CITY OF ALBUQUERQUE

RE: Lot 6 Block 9 Unit 5 SAD 227 Volcano Cliffs 6220 Keyenta Rd. NW **Grading and Drainage Plan Engineers Stamp Date 2/5/2021 (E10D098)**

Pad Certification Date 3/16/2021

LOT 6 BCK 9 U 5 VC 6220 KEYENTA PLACE NW GRADING AND

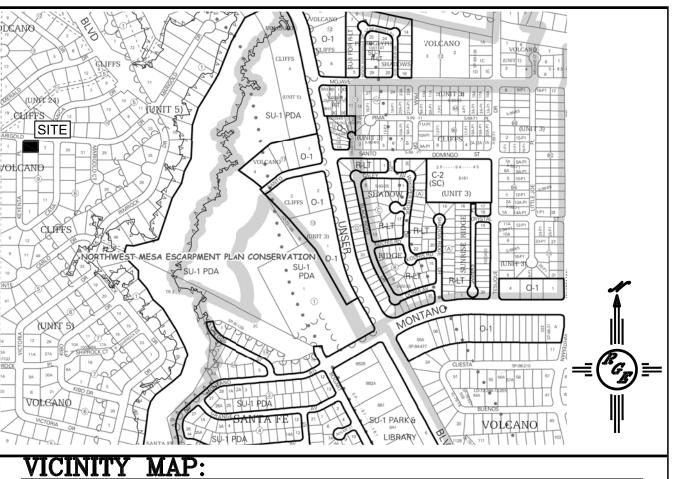
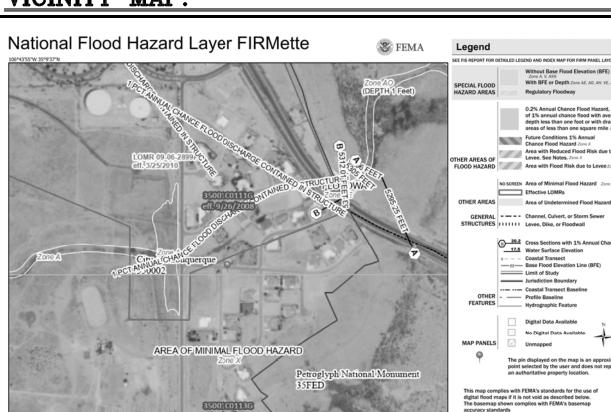
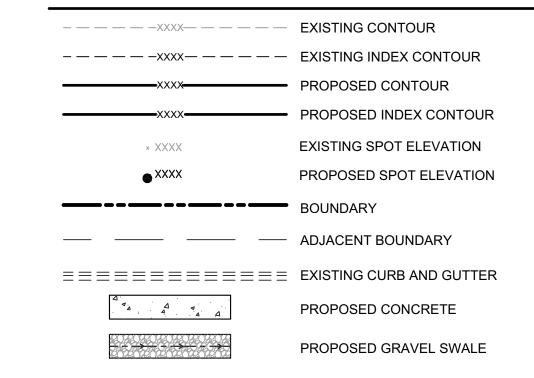
PO Box 1293 Based upon the information provided in your submittal received 3/17/2021, this plan is approved

for Building Permit.

Reiterate to the Owner/Contractor that a separate permit for a garden/retaining wall must NM 87103

be obtained, with the approved G&D plan.

Prior to Certificate of Occupancy release, Engineer Certification per the DPM checklist of this www.cabq.gov plan will be required.
